PCN # ESW490-46 – Alternate Assembly Location for IXYS Power Thyristor & Diode TO-220AB_AC Package

Product/Process Change Notice (PCN)

PCN Report

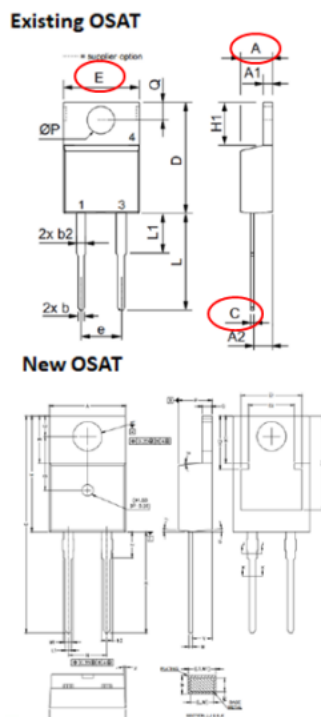
- Comparison of Package Detail Dimension between Existing Assy Site and Alternative Assy Site.

TO-220AC POD SPEC gap in A, C&E. But the actual measurement data all within Littelfuse SPEC.

Conclusion: The variance is not critical which has no significant impact on customer application.

Tube dimension:

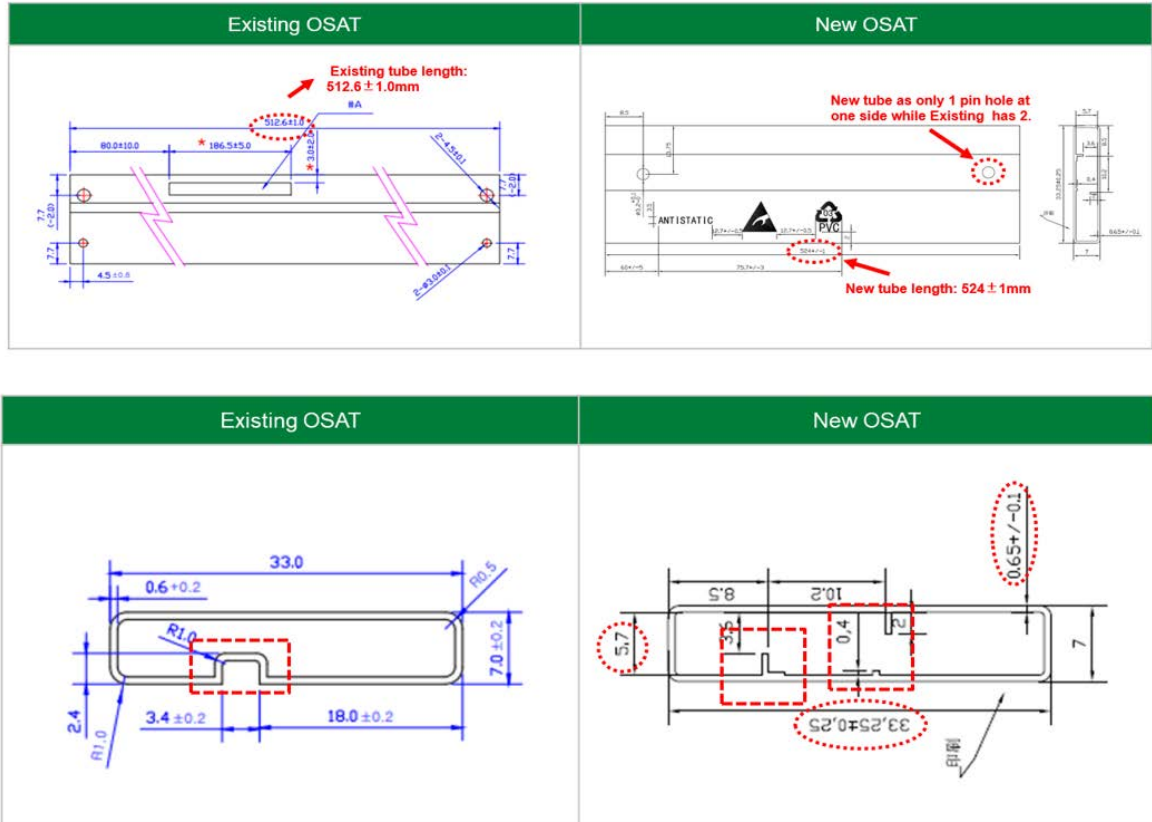
- Inner/Outer Box dimension & packing qty: Alternative Assy site's packing box is smaller than existing Assy site which lead to less packing qty. But it does not affect the MOQ.
- Tube dimension: Alternative Assy site's packing tube for TO-220 is different from existing Assy site. The difference may or may not impact the device unloading at customer side.
